WATERLOO METRO QUARTER OVER STATION DEVELOPMENT

Environmental Impact Statement
Appendix H – BCA and DDA Assessment Report

BCA & DDA Assessment Report

Waterloo Metro Quarter Development
Building 2

1 Level 01 - Indoor Outdoor Play
 1:200

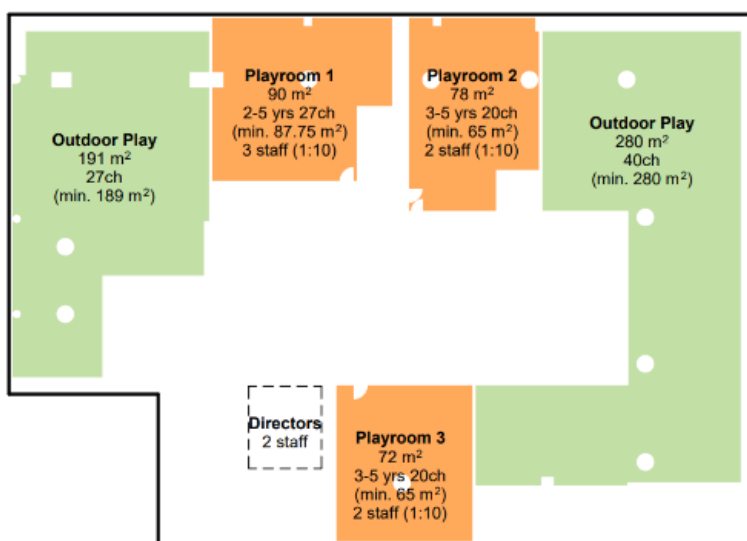
Level 1: 67 children, 9 staff
 Level 2: 64 children, 14 staff

Figure 6: Non-Compliant Doorway Circulation Space at Level 2 Playroom 4 Entry

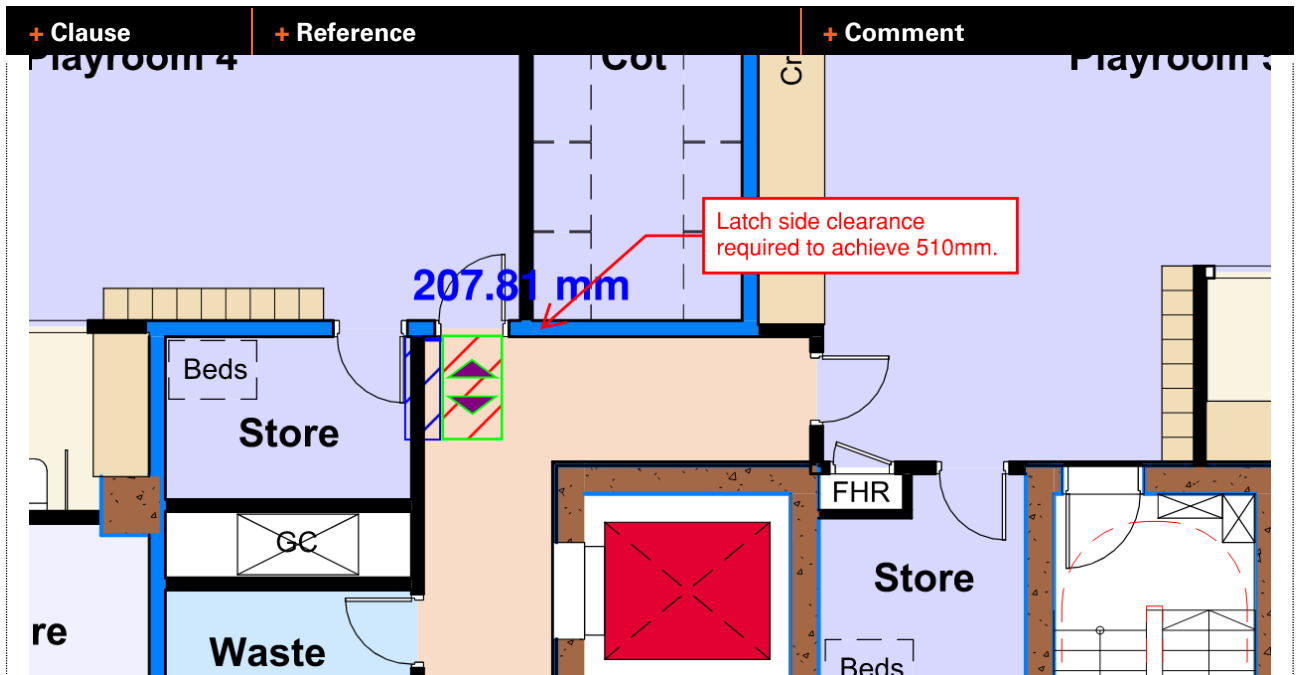
2.	D4D4 – doorway circulation	The cot room in playroom 4 of the childcare centre does not achieve doorway circulation. Either provide or we can support as a performance solution.
